DART AEROSPACE LTD	Work Order:	105220
Description: Crosstube Assembly (205/212 High Aft)	Part Number:	D212-664-241
Inspection Dwg: D212-664-241 **Rev:** D		Page 1 of 2

DESIGN	PH	DART AEROSPACE LTD HAWKESBURY, ONTARIO, CANADA
DRAWN	RF	
CHECKED		DRAWING NO. REV. D
MFG. APPR.		D212-664-241 SHEET 1 OF 4
APPROVED		TITLE SCALE
DE APPR.		CROSSTUBE ASS'Y (205/212 HI AFT) NTS
DATE	09.09.30

DRAWING NO.	TITLE	REV. D	DART AEROSPACE LTD	D.E.O. NO.	SHEET NO.	SCALE
D212-664-241	CROSSTUBE ASSY (205/212 HI AFT)		ENGINEERING ORDER	D212-664-241-D-1	SHEET 1 OF 2	NTS

PURPOSE:
ADD AN INSPECTION WINDOW TO UNDERSIDE OF CROSSTUBE.

D212-664-241/-241B
ASSEMBLY DETAIL

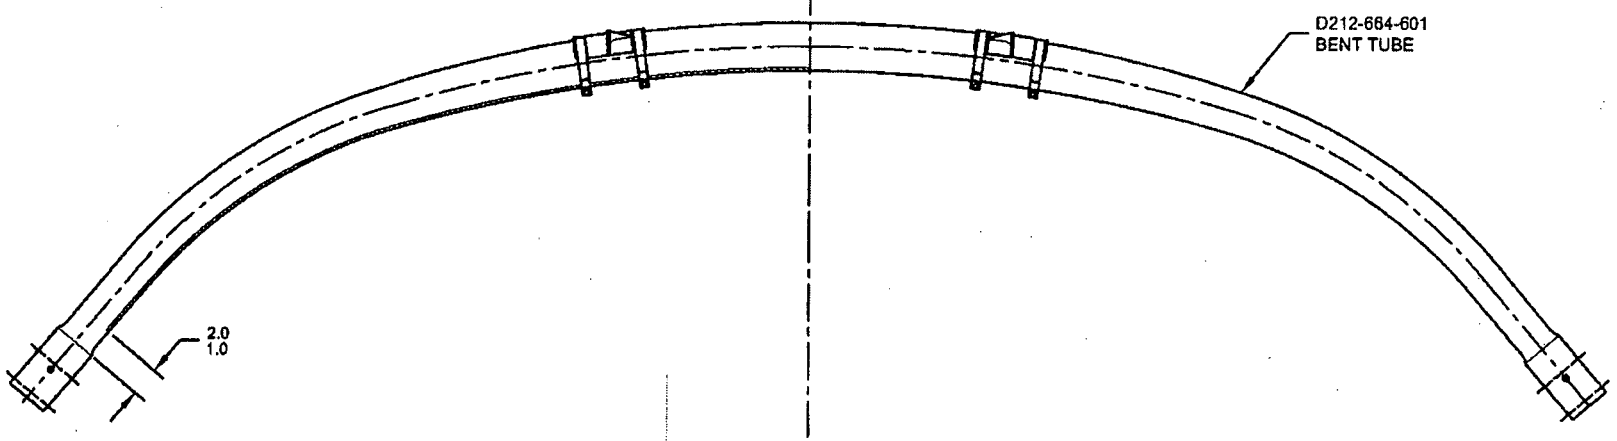
CHANGE:

NOTES 2 OF SHEET 1 IS AMENDED AS FOLLOWS:

IS:

WAS:

2) FINISH: CHEMICAL CONVERSION COAT PER DART QSI 005 4.1
PRIME INSIDE AND OUTSIDE PER DART QSI 005 4.2
MASK UNDERSIDE OF CROSSTUBE AS SHOWN (HATCHED AREA) AND
PAINT OUTSIDE PER DART QSI 005 4.2
REMOVE MASKING AND APPLY CLEAR COAT
